Department of Energy

June 26, 2000

The purpose of this letter is to inform the Environmental Protection Agency that the Carlsbad Area Office (CAO) plans to raise the repository horizon in Panels 3, 4, 5, 6, and 9 by approximately two meters so that the roof is at clay seam G. The Waste Isolation Pilot Plant intensively monitors the geomechanical behavior of its underground excavations. Actual monitoring of underground excavations, specific underground studies, and geotechnical modeling (e.g., DOE-WIPP 94-025, Investigation of the Advantages of Removing Highly Fractured Roof Beams), all demonstrate that positioning the roof at clay seam G improves ground conditions in the repository and provide a more stable roof configuration without significantly impacting repository performance. Raising the repository horizon reduces the rate at which ground deteriorates (i.e., slower roof beam deformation rate and slower development of fractures), thus reducing risks during mining and waste handling operations.

Figure 3-2. Plan View of WIPP Underground Facility and Panel Closure Systems

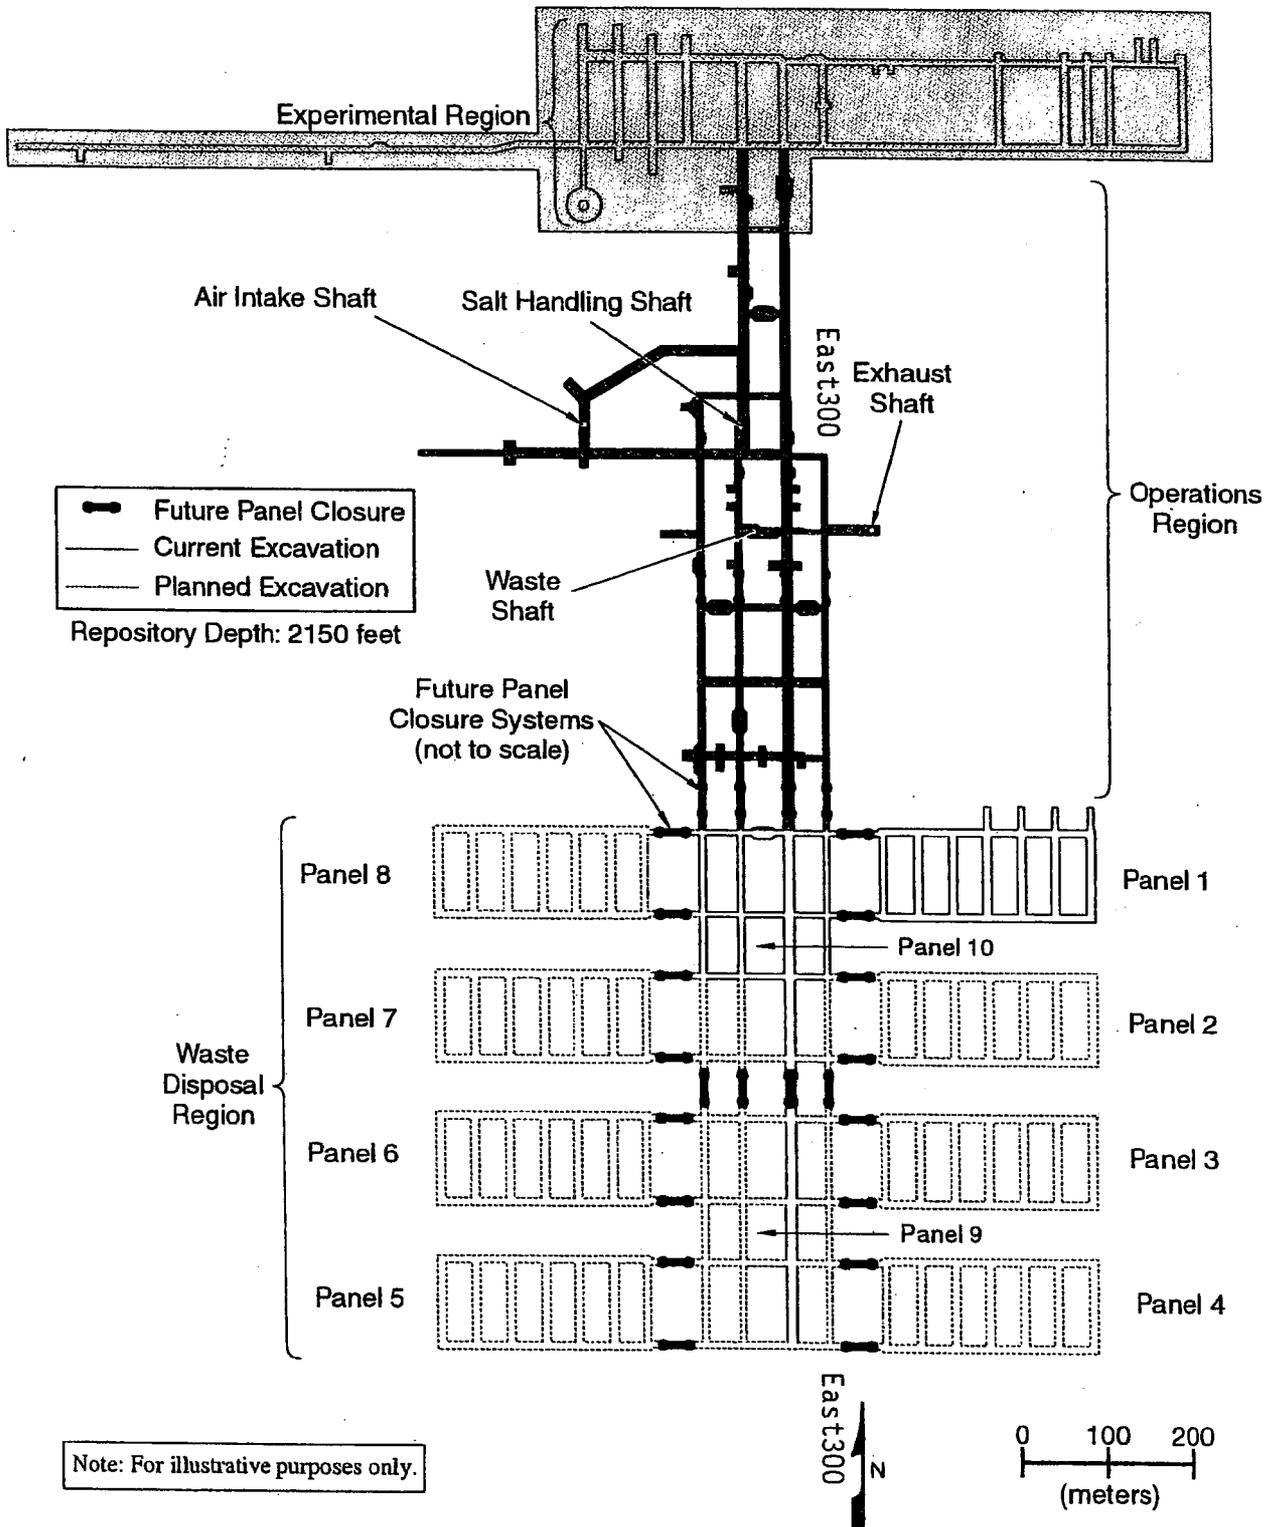
The repository horizon for Panels 3, 4, 5, 6, and 9 will be raised so that the roof is at clay seam G (shown on the attached Figure 3-6). Raising the repository horizon will be initiated in the East 300 drift (shown on the attached Figure 3-2) which leads into Panel 3. Raising the repository horizon now and in this location will result in improvements in safety and in operational efficiencies. This does not imply that there are underground safety concerns associated with the present situation; however, by raising the repository horizon by about two meters, ground conditions will be improved and considerably less maintenance will be required to assure optimum ground conditions.
